PUBLIC NOTICE
CITY OF BEXLEY

a. Application No.: BZAP-20-7

Location: 30 N. Drexel Ave.

FOSTER RESIDENCE
 30 N. DREXEL AVE.
 BEXLEY, OHIO
 SCHEMATIC DRIVE LAYOUT

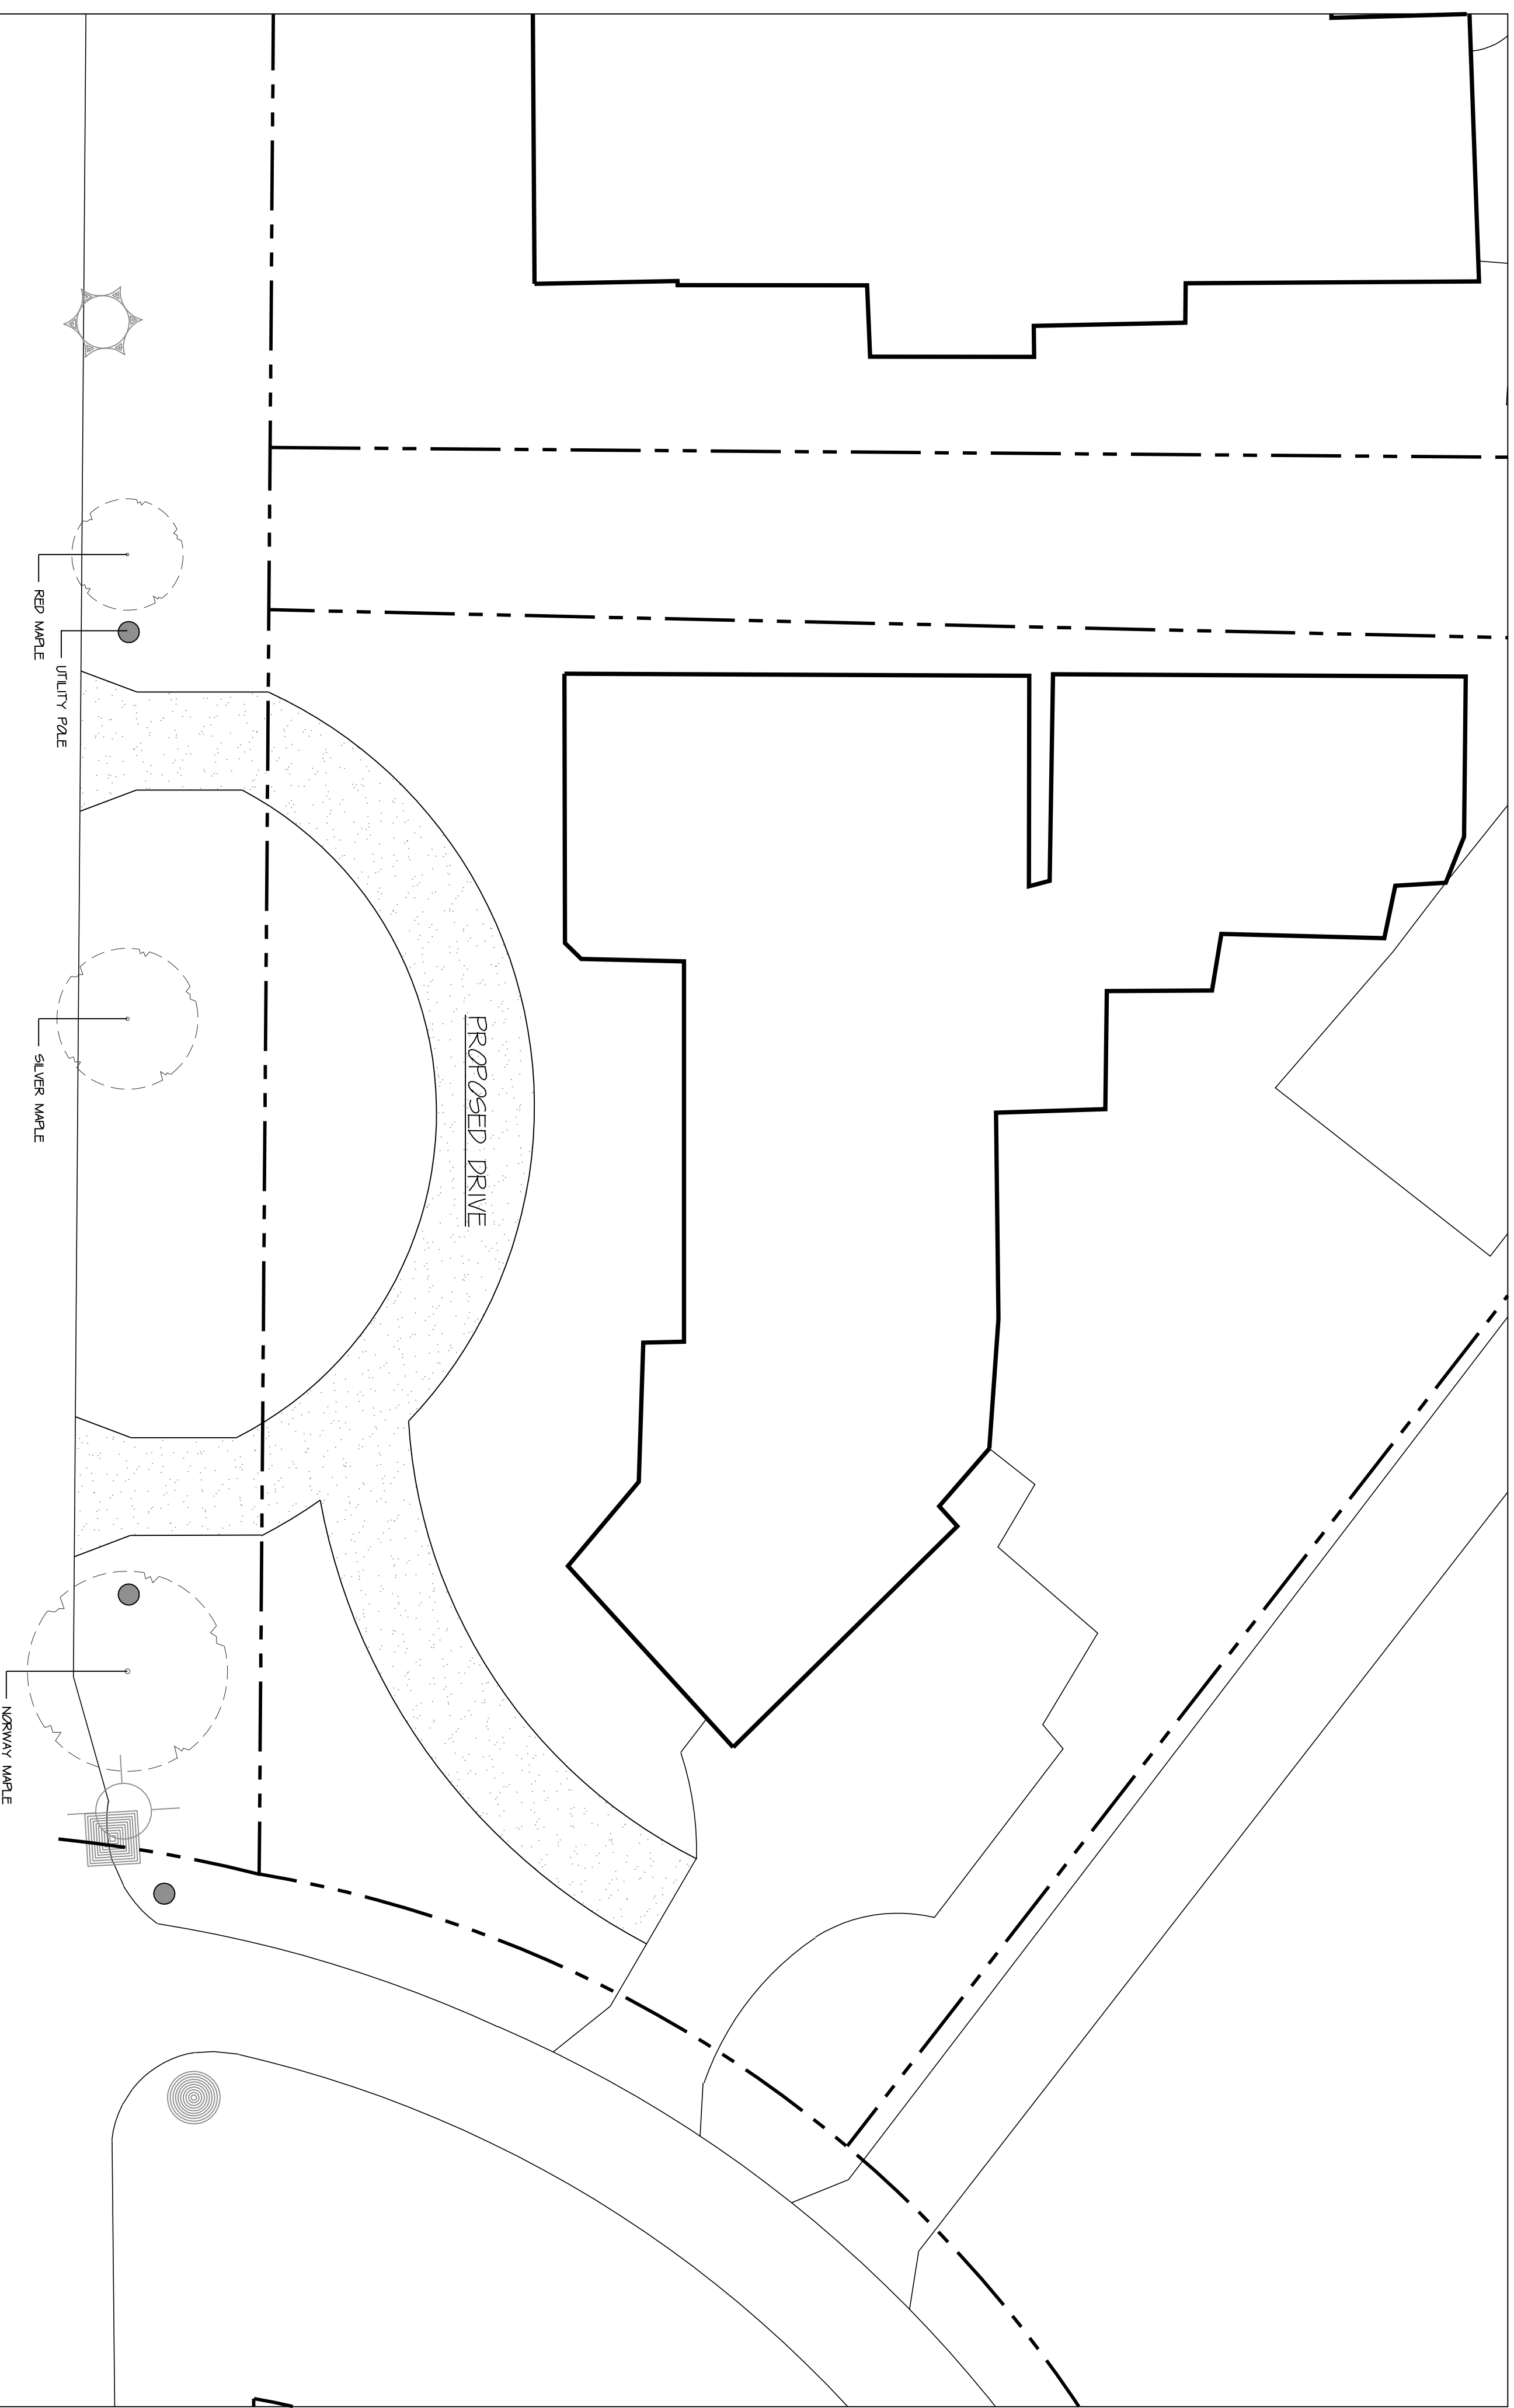
Mark - what is the width of the proposed driveway?

12.5' is the limit for width - If it stays at 14, that would be a variance. Also, could you indicate the distance the approaches would be located from each other and how far the southern approach is from the southwest corner (Drexel Ave. and Drexel Circle)

What is the total lot coverage - building plus hardscape? Also there are two approaches in the front yard.....I was planning to add you to my March 26th Agenda.

Will any trees along the Drexel Ave. side of this property be affected?

Trees located between the curb along Drexel Avenue to a point approximately 8' behind the sidewalk are all city trees and cannot be removed without approval from the Tree & Public Garden Commission.

Marc: Can you provide the amount of hardscape in the front yard which includes the existing and proposed drive (This would be on the section of yard that fronts on the circle and from the front of the house to the front property line and from the side property line on Drexel to the lot to the southeast.

I think that may be a part of the review by the Zoning Board, as the circular drive typically connects to the off-street parking in an approved location (which in this case is the garage) as the circular drive detached from the garage access can only encourage parking in the side yard that appears as front yard parking, on this irregular corner lot. I would leave that up to the Board.

It is drawn at 14' wide.

If this will already be a variance, i would rather leave it at 14' wide for now. But, if the width is the only part of the project that would require a variance, we can adjust it to 12.5' wide.

Here are the current numbers, but we will be re-designing the drive & patio area, so it might change. The total lot: 41,100 sf
Hardscape/building: 19,500 sf (47.44%) Drive addition: 2,800 sf Yes, two approaches

Great We are not currently planning on impacting the existing trees. But would like to know about replacing them since they are less desirable trees.

Kathy, based on the current layout: Coverage with existing drive: 18.79% Coverage with existing & proposed drop-off/connection: 40.64% Coverage with existing & no connection drive: 20.57% In the final design the connection between the drop off drive and drive to the garage may be removed from the plan.
